DESIGN REVIEW COMMITTEE

August 21, 2024 6:00 PM

**DEPARTMENT OF PLANNING AND ZONING
PLANNER'S REPORT**

RE: Design Review – 3293 Dogwood Drive

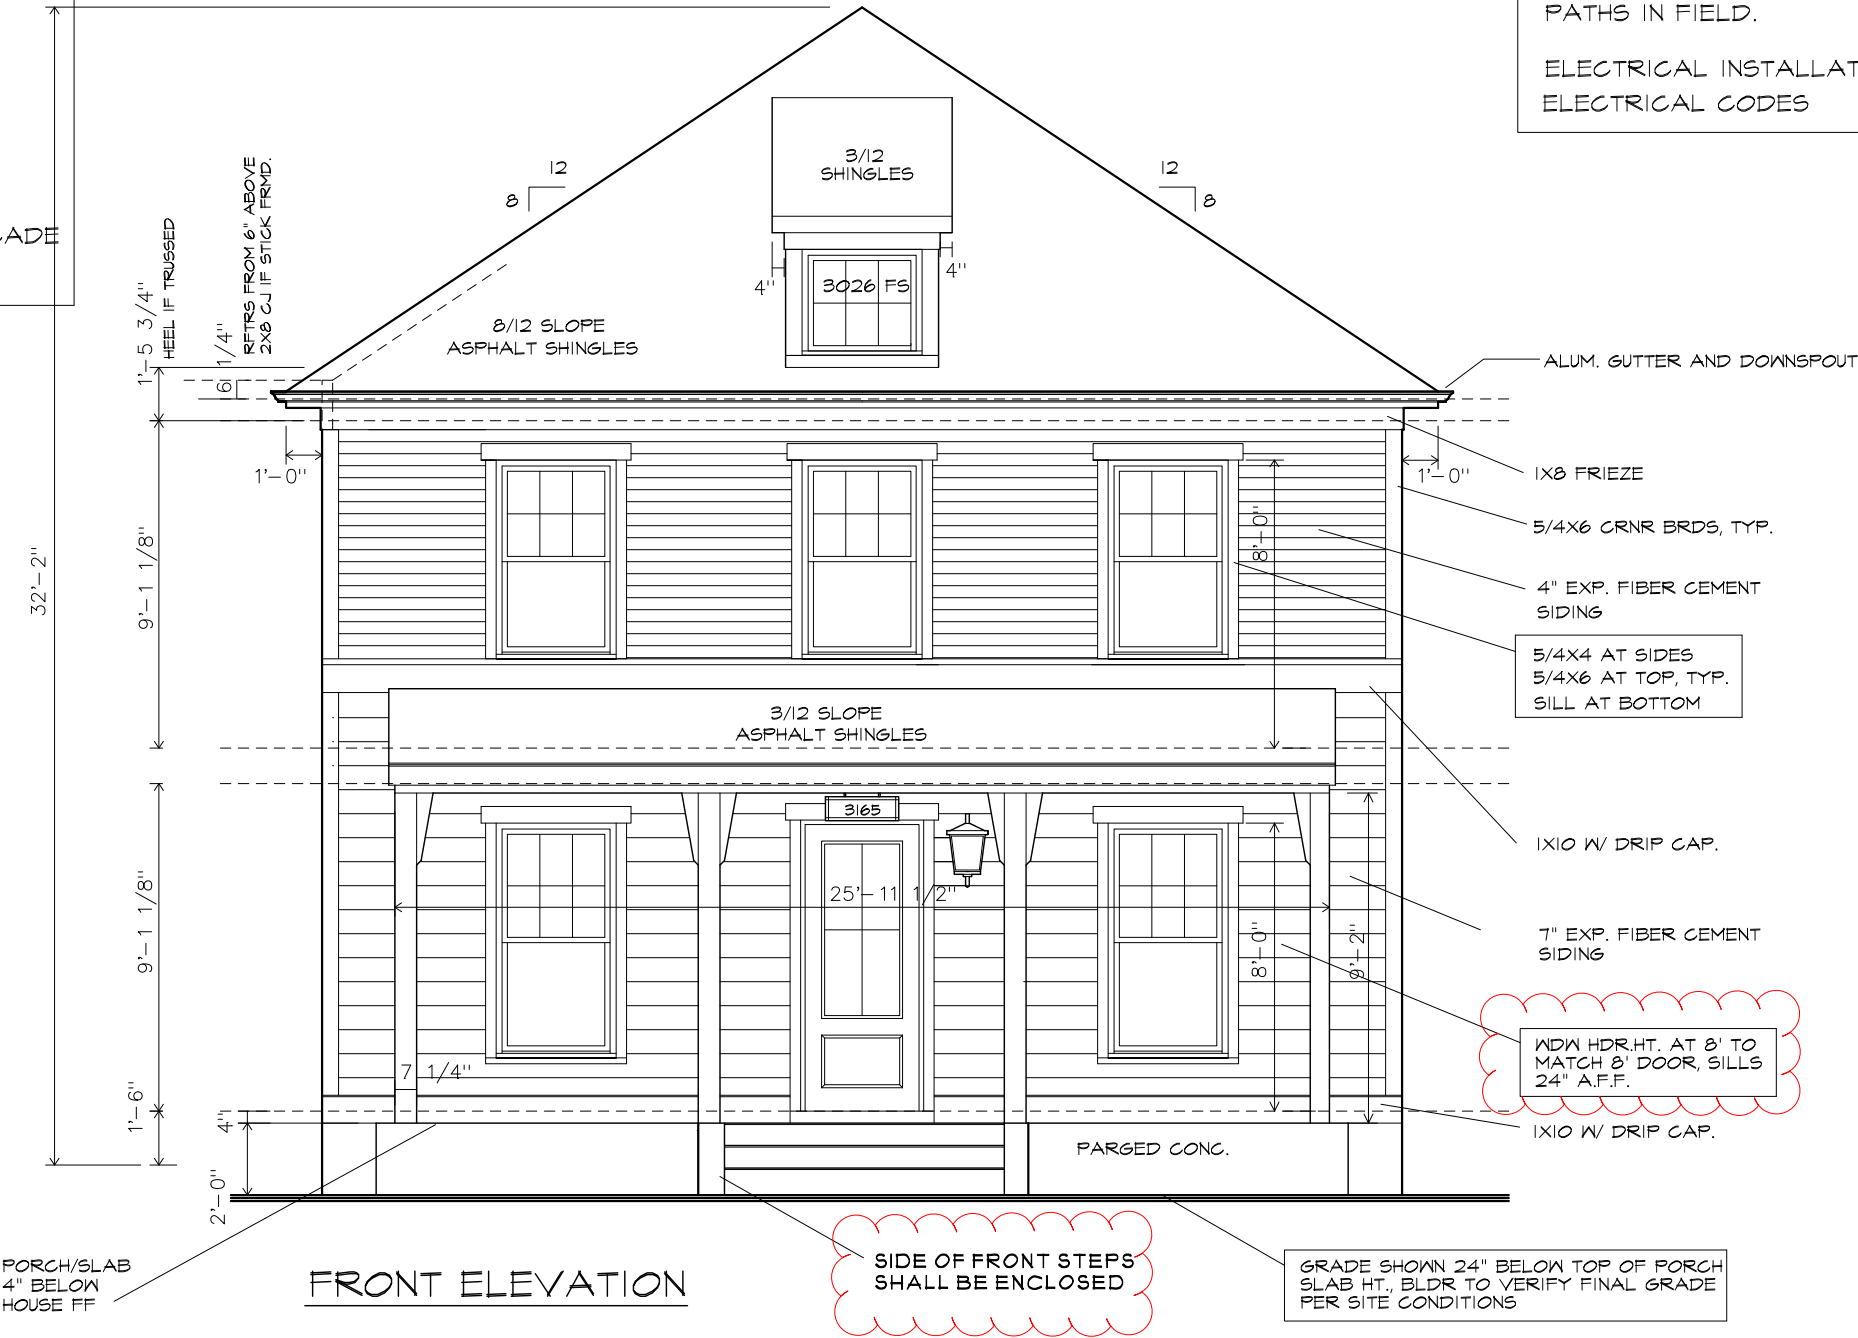
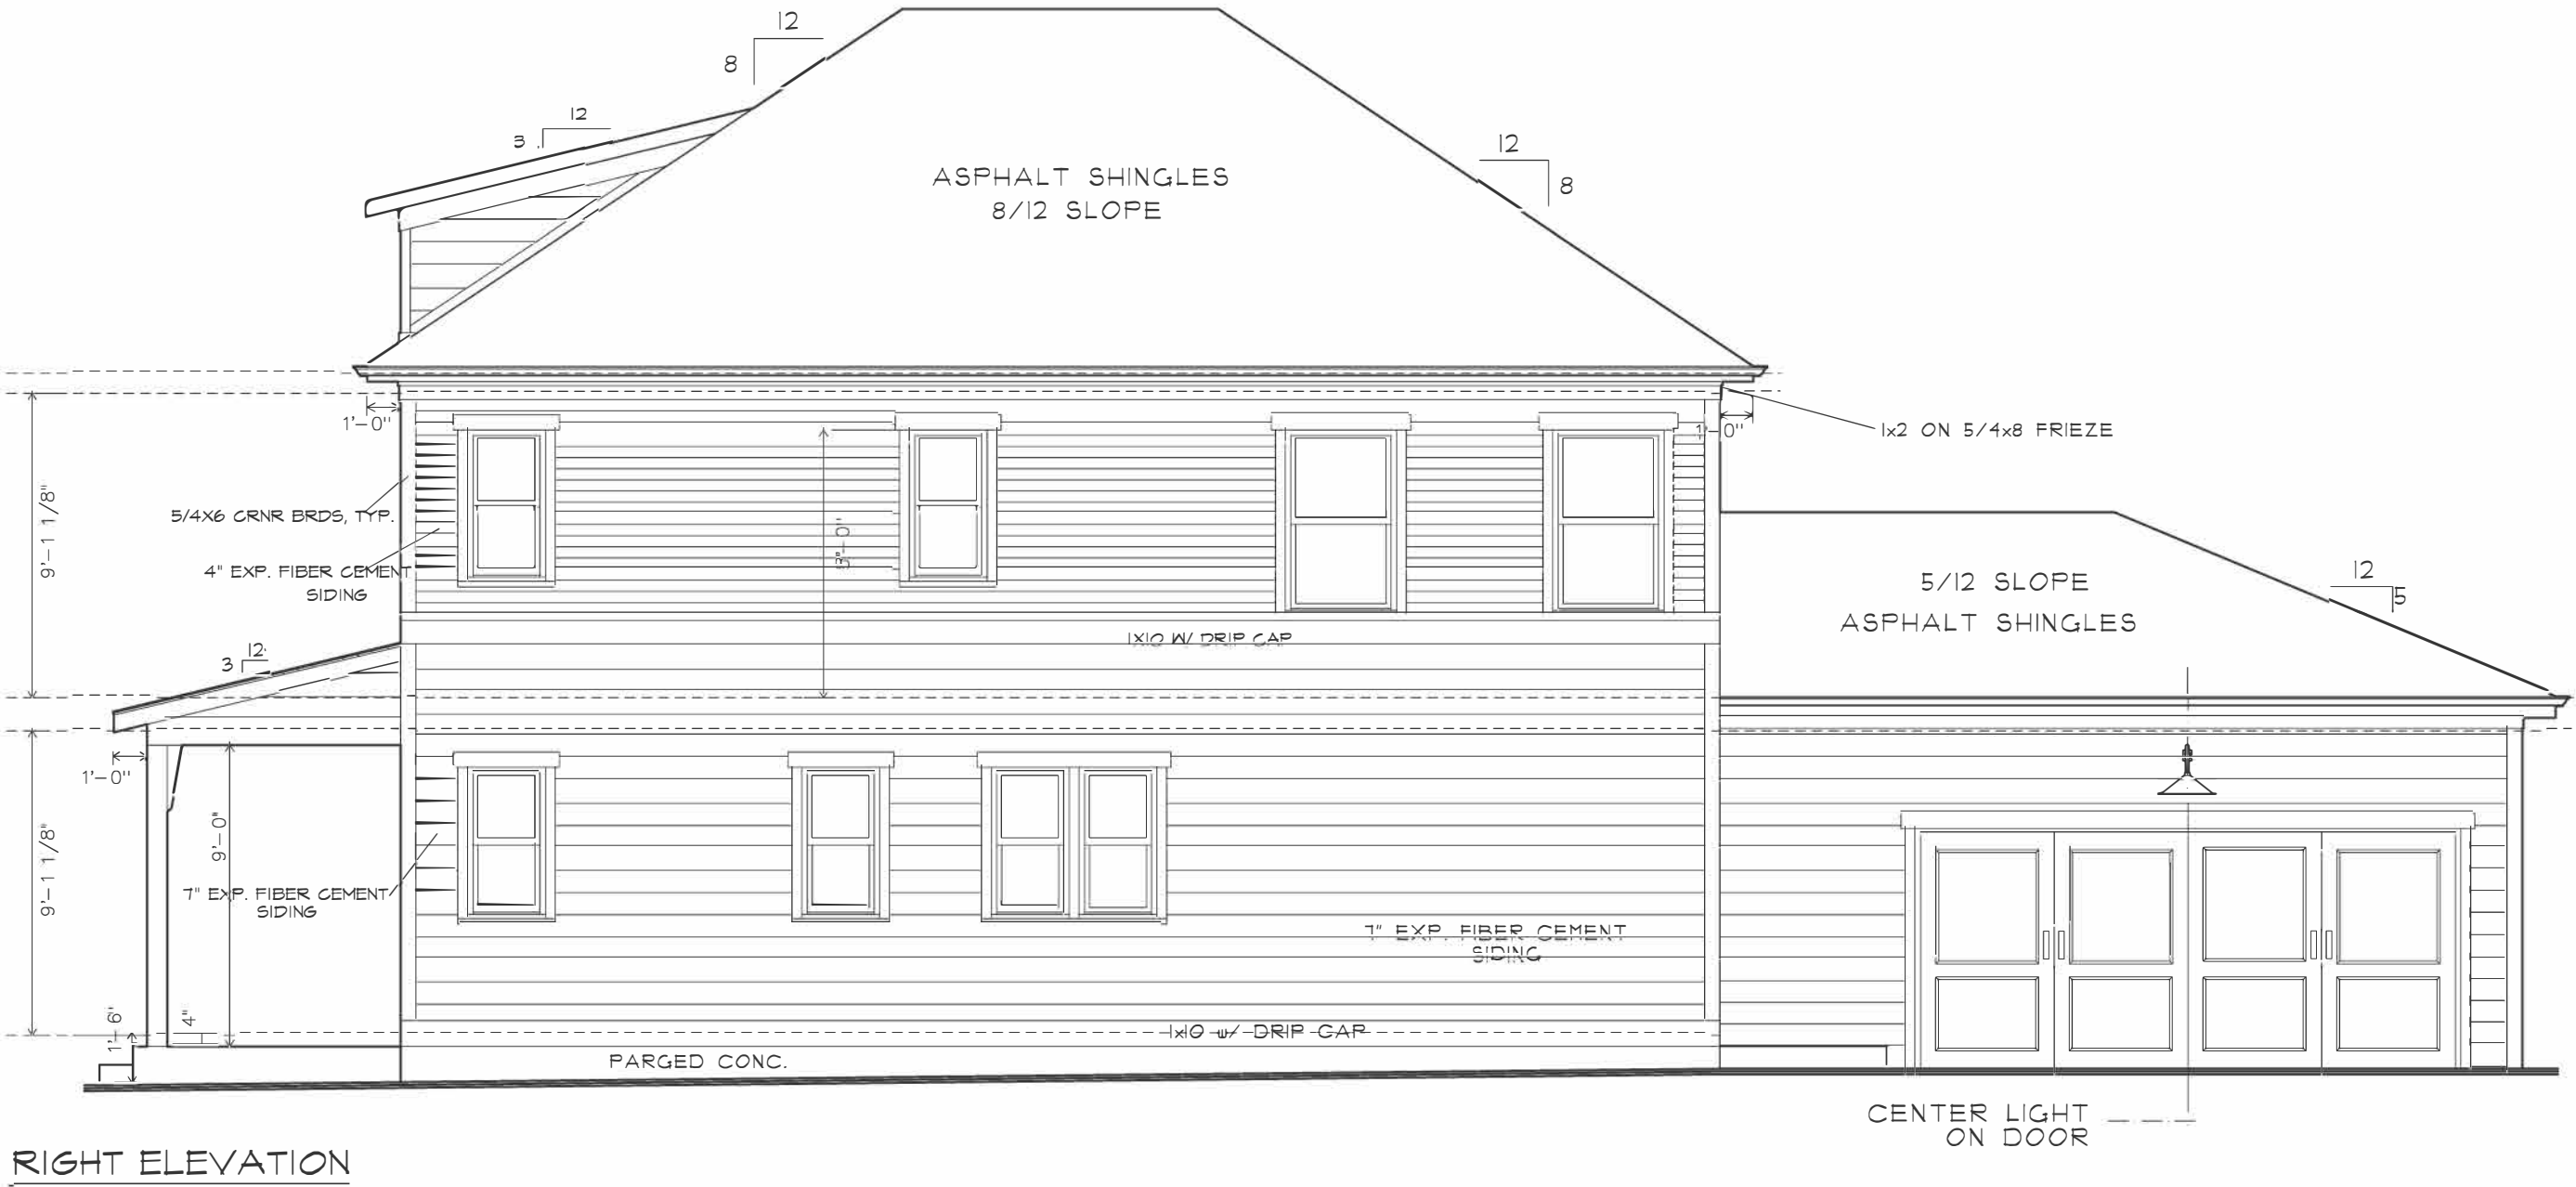
The City of Hapeville has received a revised design review application from Daniel Love of 3ELKS Design Ventures, for the removal of a dormer on the single family dwelling at 3163 Old Jonesboro Road. During construction, the contractor did not install the dormer in error – he constructed it on the adjacent lot.

Staff recommends approval of the modification. The roof style is consistent with Design Standards and had been approved on the adjacent property.
